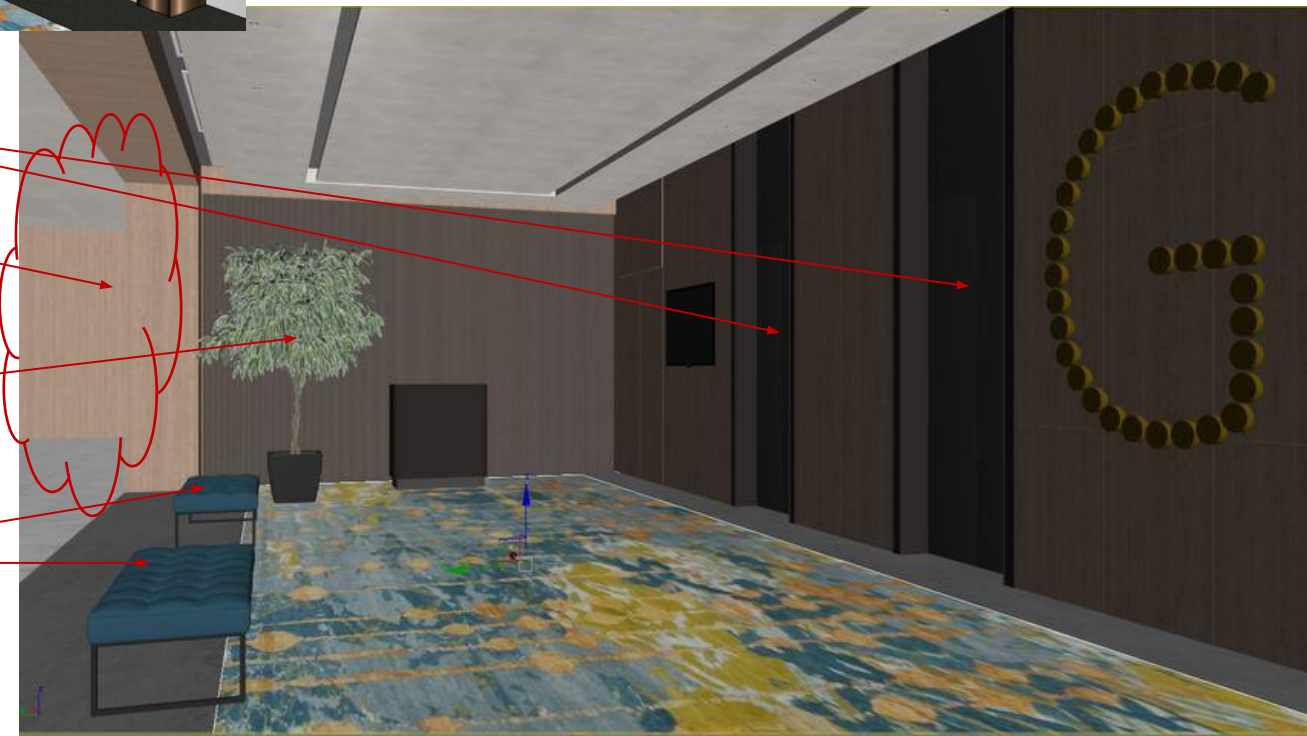
View and angle to follow as per sketch up!
Rendered view needed to comment further.
To have day sun light.

Perimeter Cove light around recess ceiling

lift car frame in
s/steel hairline finish

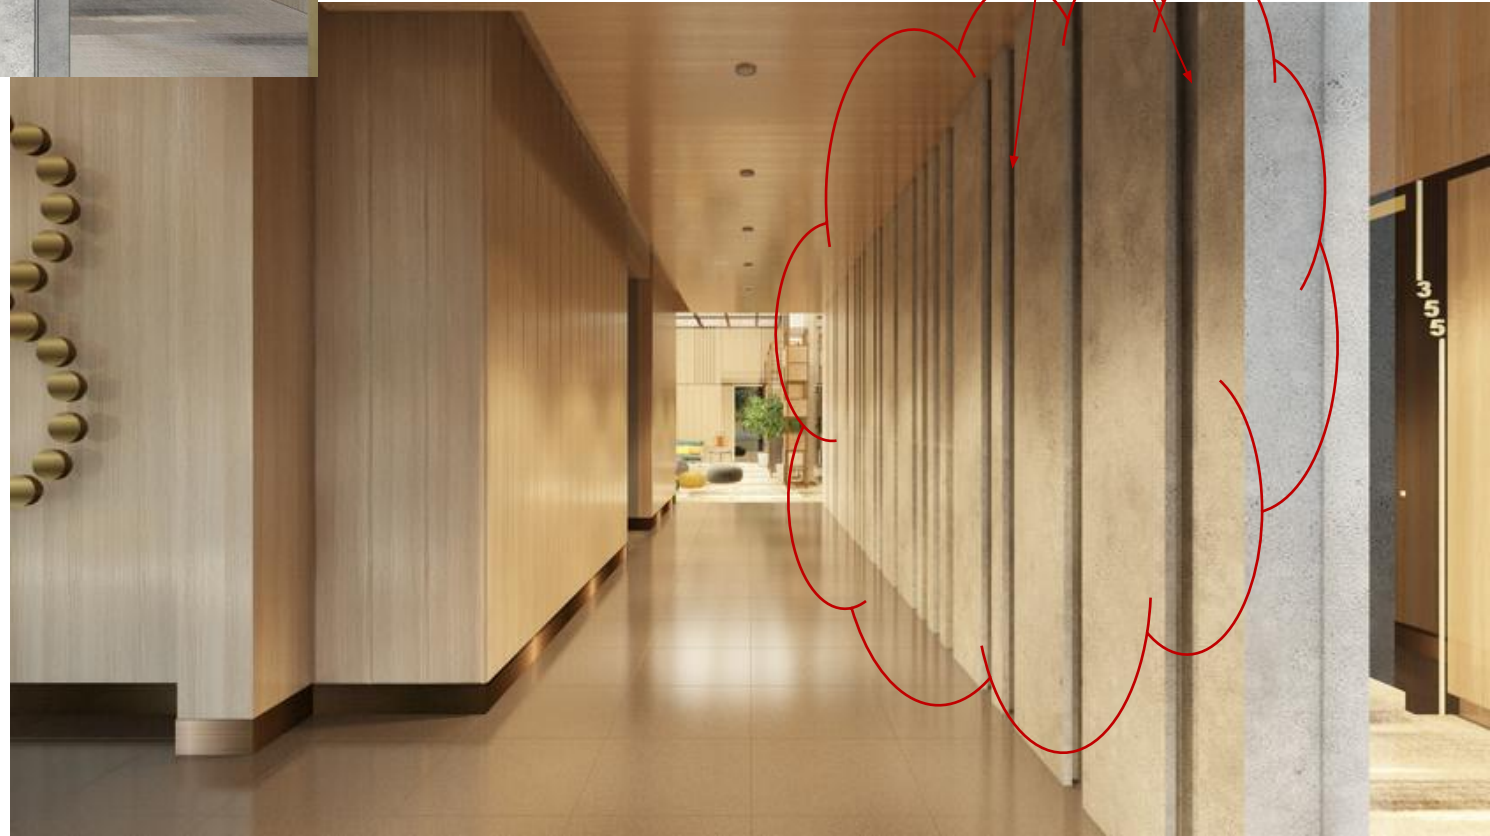
View and angle to follow as per sketch up!
Rendered view needed to comment further.

Lift car in s/steel hairline finish

Glass door to add as per sketch up

Plant to follow as per sketch up

Furniture arrangement to follow
as per sketch up

Too yellowish, less down exterior sunlight!
To show more interior lighting

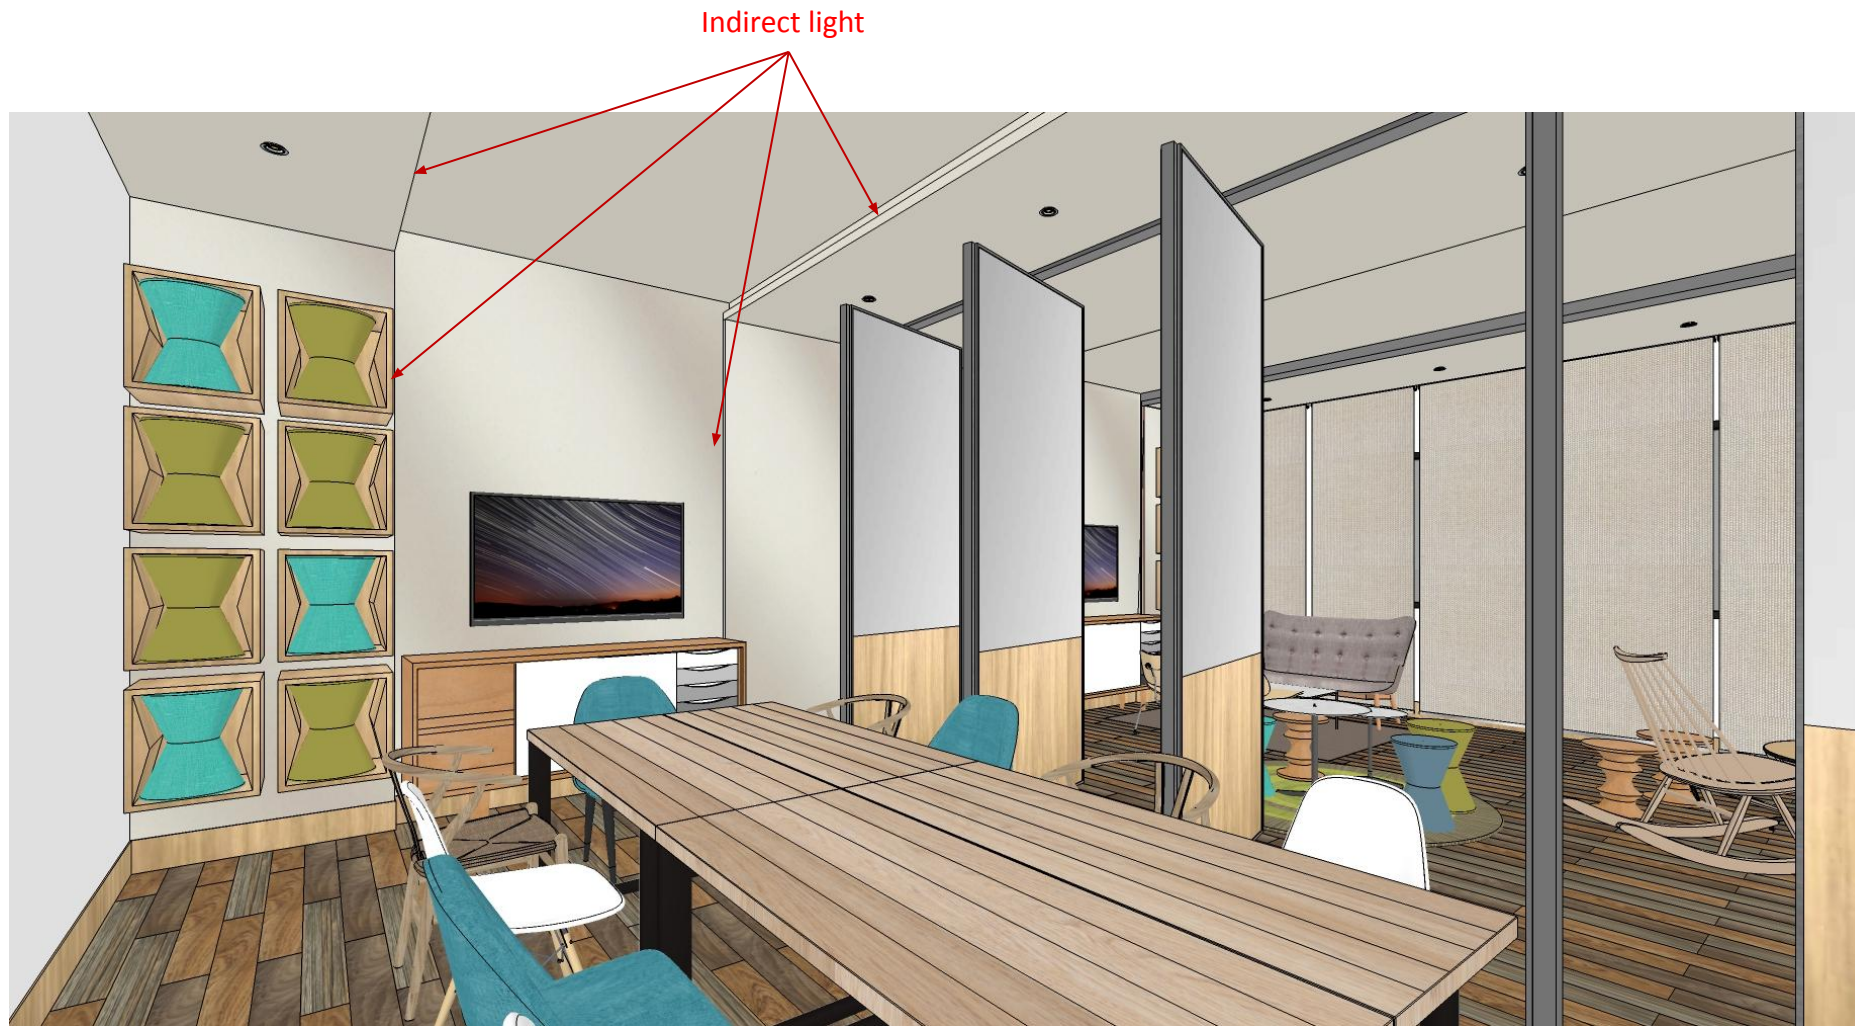
View and angle to follow as per sketch up!
Rendered view needed to comment further.

Full piece of mirror
As per sketch up

Door frame too thick.
30mm will do.

Deco follow to follow
type A1 bath

Moveable panel top part in colour glass finish.
